February 11, 2013

SAFETY RECALL NOTICE – SAYFLINK SLEEVE **Immediate Action Required**

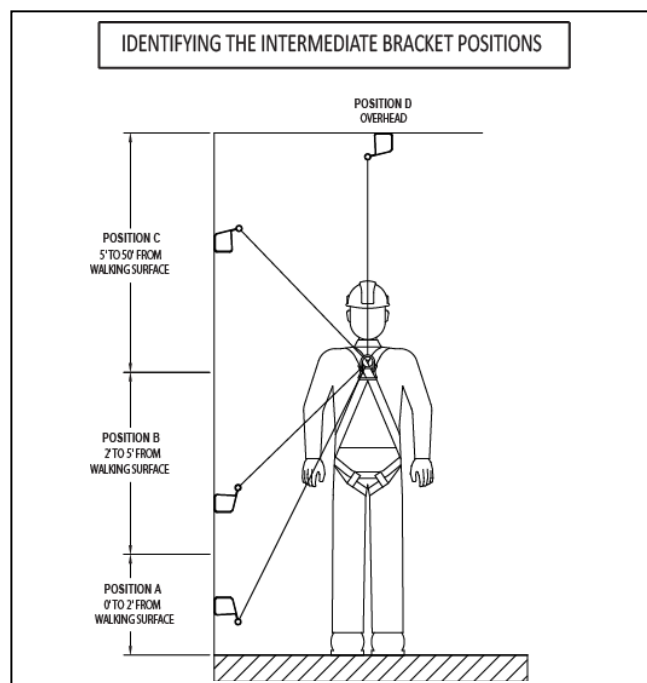
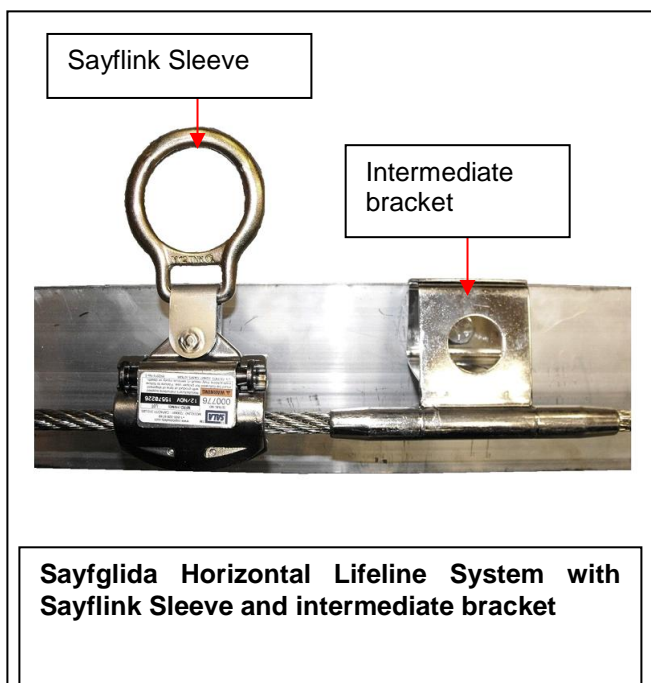
The reason for the recall is that, when the intermediate brackets are installed at walking surface level (between zero and two feet above the walking surface as illustrated in Position A below), there is a remote possibility that the sleeve can disengage from the cable as it slides over an intermediate bracket while trailing a worker moving across the walking surface. See “Identifying the Intermediate Bracket Positions” below.

Although Capital Safety’s testing shows the Sayflink Sleeve is safe to use in bracket positions B, C and D as illustrated above (and any height between these positions), out of an abundance of caution, Capital Safety is recalling all Sayflink Sleeves regardless of the height of the permanently installed brackets.

If you have Sayflink Sleeves in service that were manufactured after May 2004, you should immediately take the sleeves out of service and call our Customer Service department at 1-800-328-6146 to arrange to return the sleeve. Capital Safety will repair or replace the sleeve dependent upon the specific needs of the end user. This will be done at Capital Safety’s expense. The free replacement applies only if the returned sleeve is in proper working condition as determined by Capital Safety; if not, charges may apply.

Alternative fall protection must be used pending receipt of the upgraded sleeve. We recommend twin-leg lanyards to maintain 100% tie-off during use of the Sayfglida System.
